A12 32 + Drawings  
E. R. Squibb & Sons, Inc.

This is in response to your letter of February 18, 1982 in which you requested additional information with respect to Squibb's Radiological Contingency Plan. Each of your comments have been addressed in the enclosure. Also included are additional or replacement pages for the required information.

### Response to Comments on Squibb's Radiological Contingency Plan

MOTORIZED AIR  
VALVE BY CONTROL  
MEG. (SEE SPEC'S)

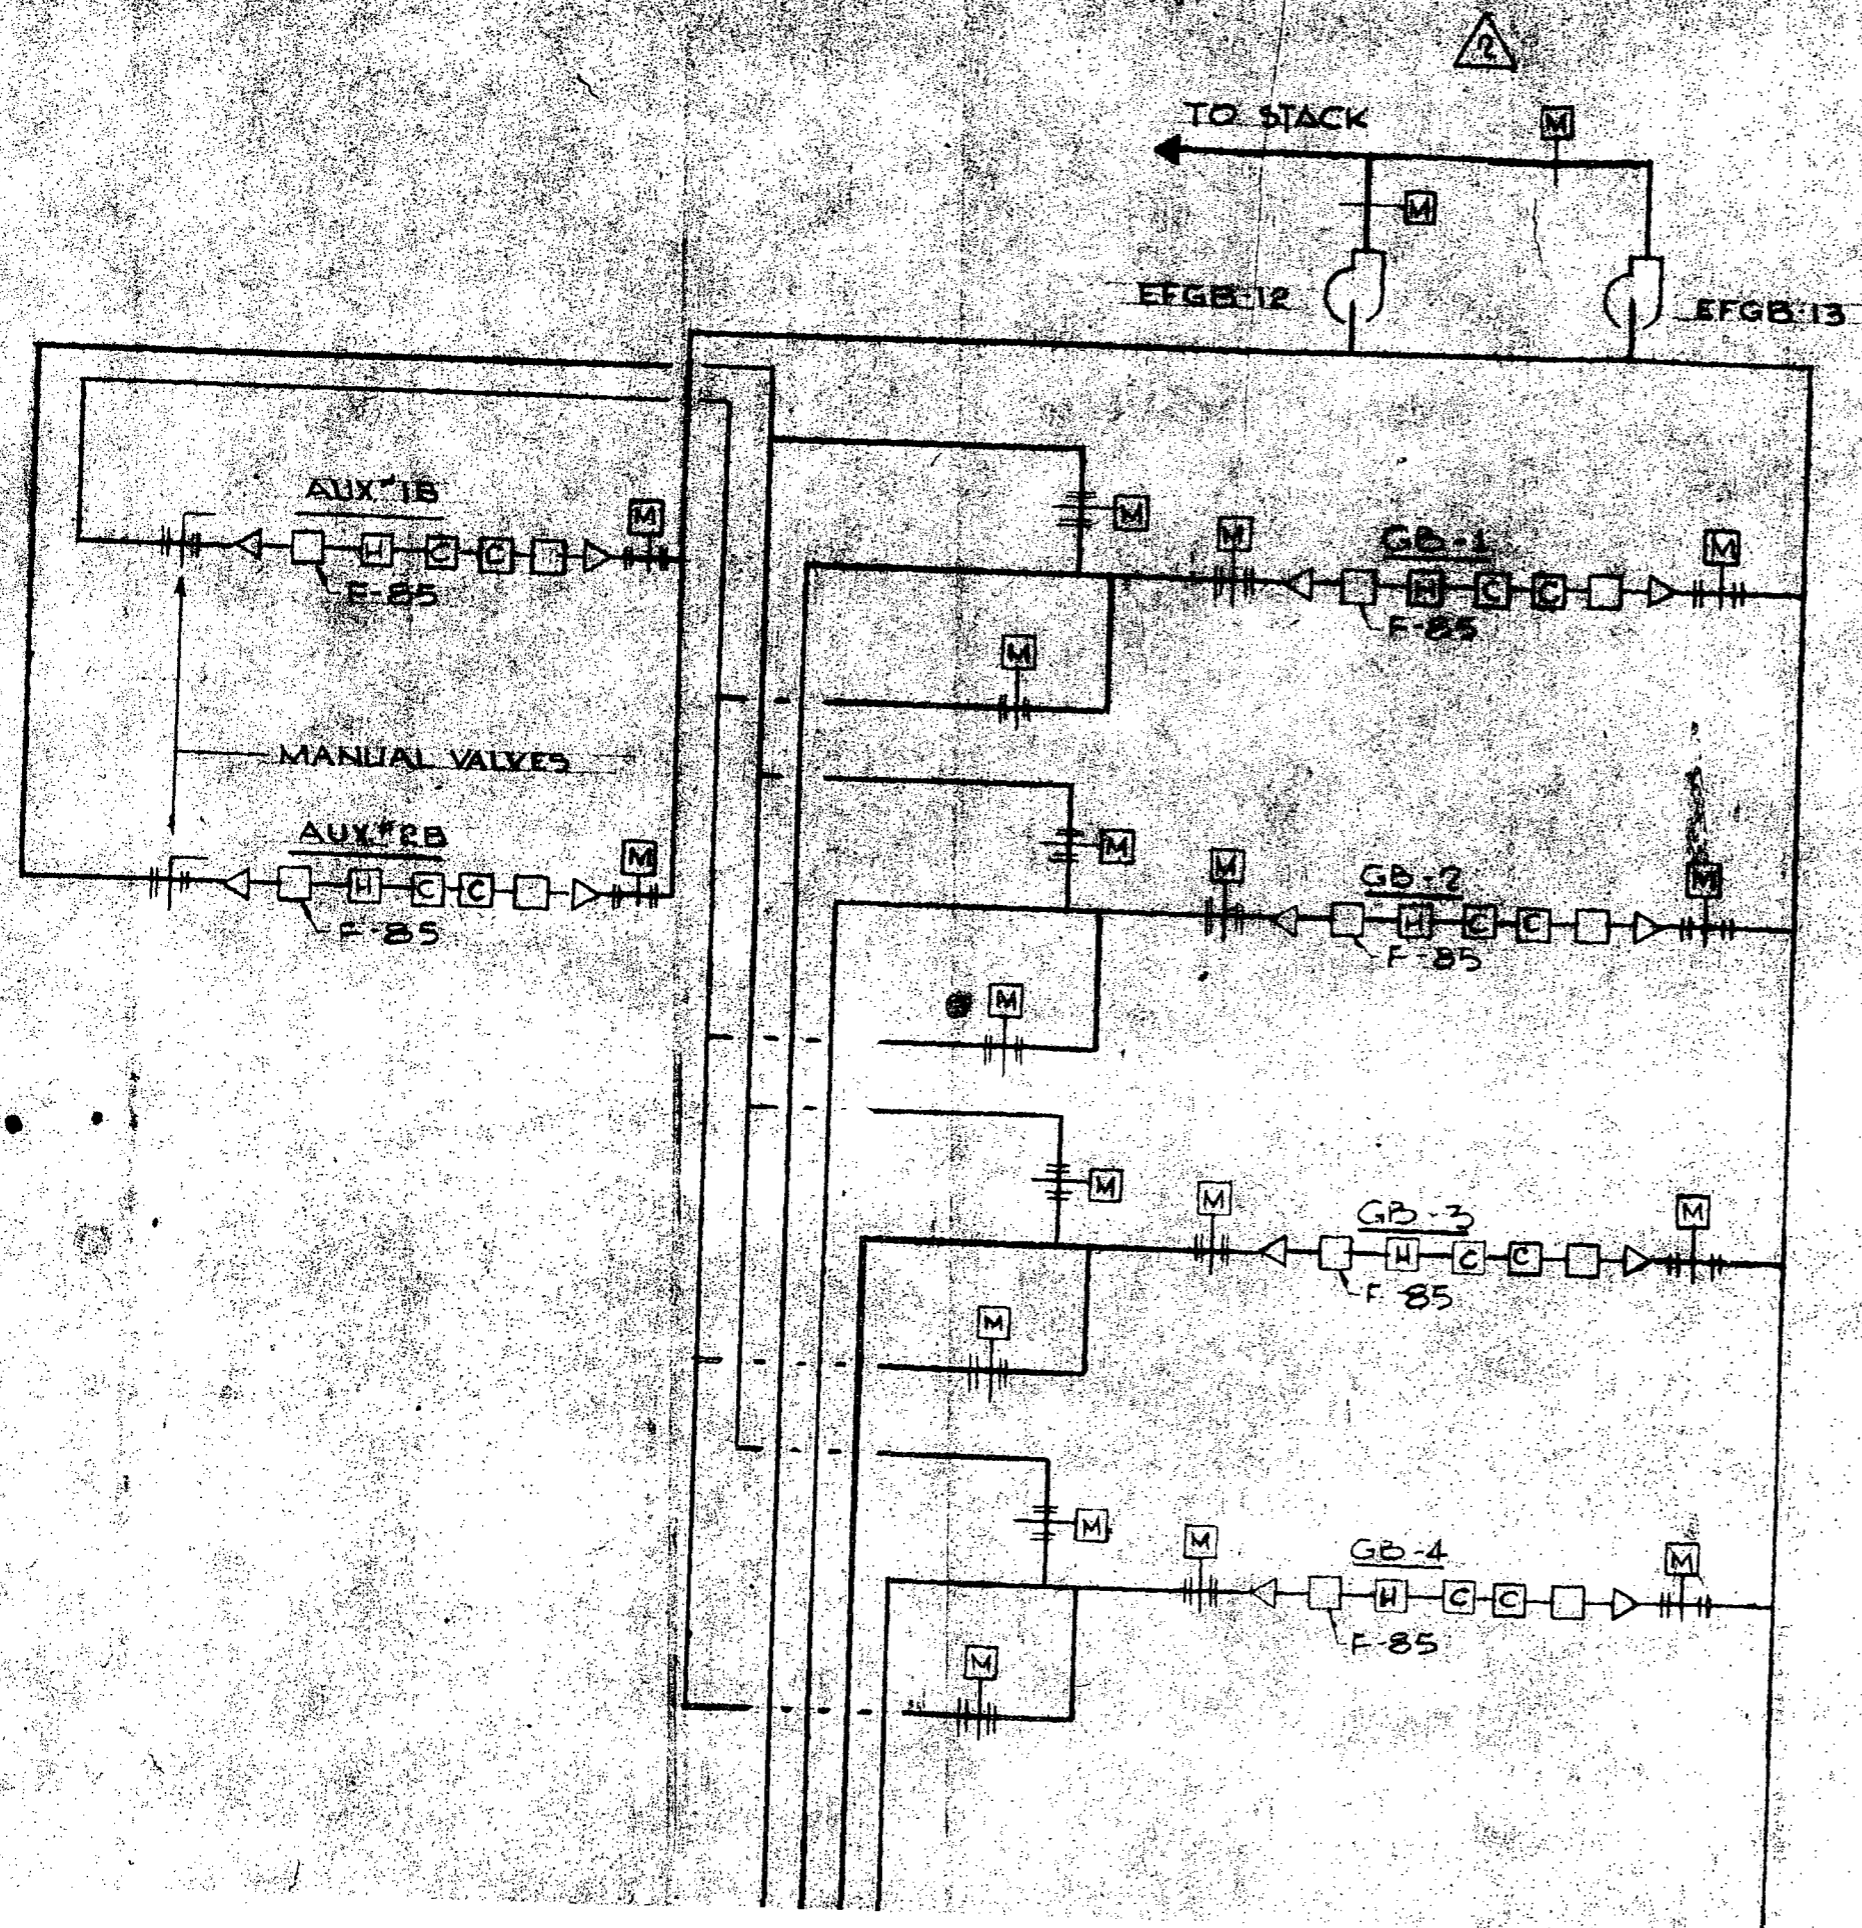
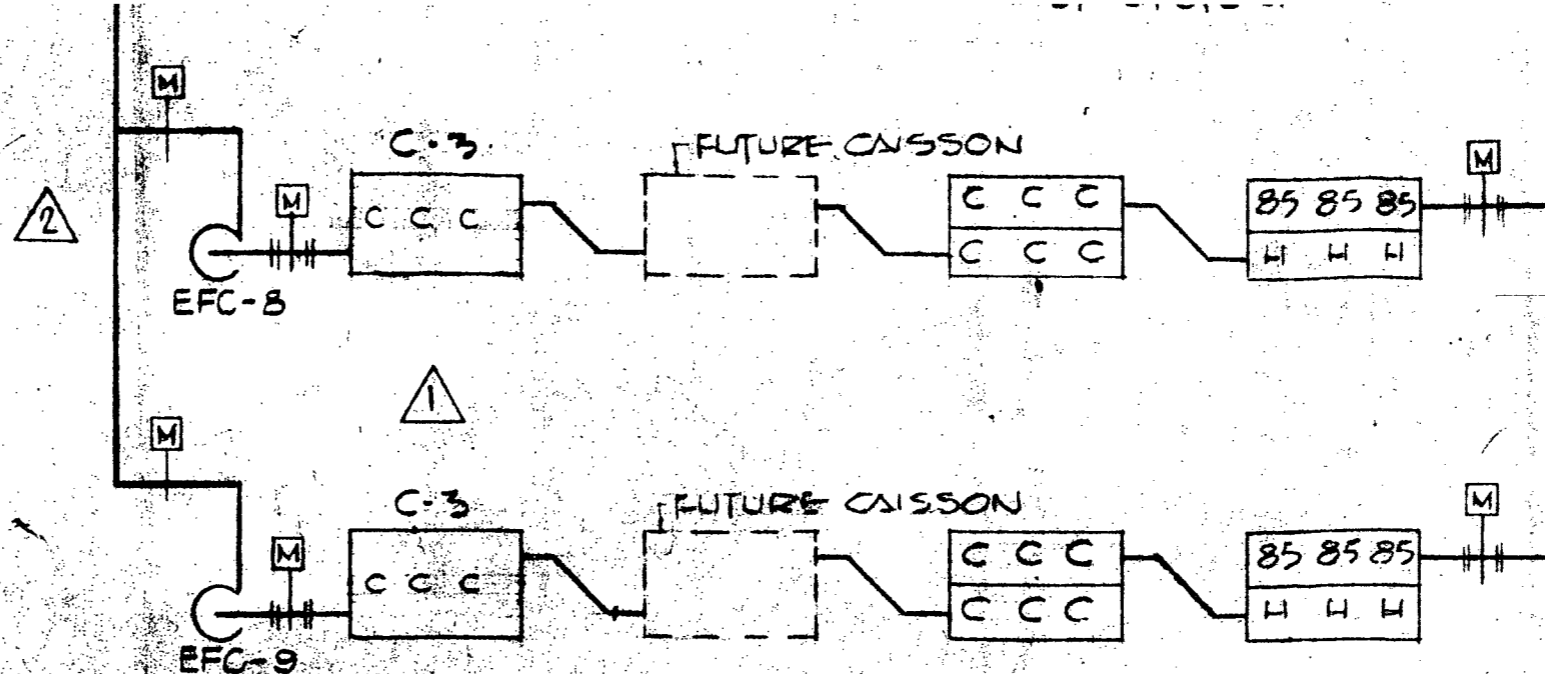
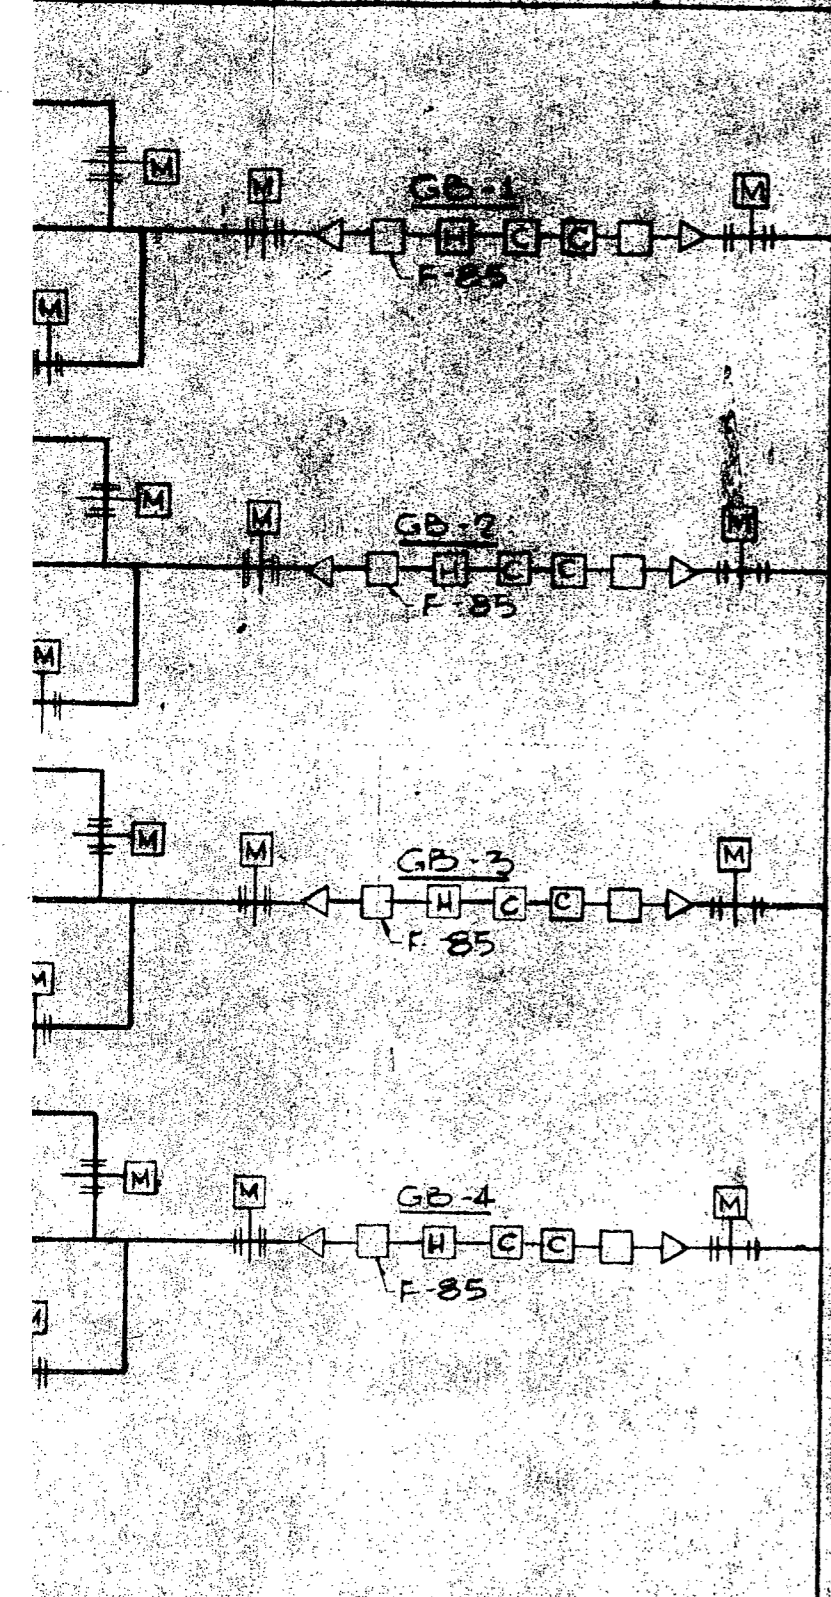
Schematic drawings showing the relationships among the glove boxes, fume hoods, hot cells and filter banks with associated ducting have been referenced in this section.

These drawings have been added as an addendum to the plan.
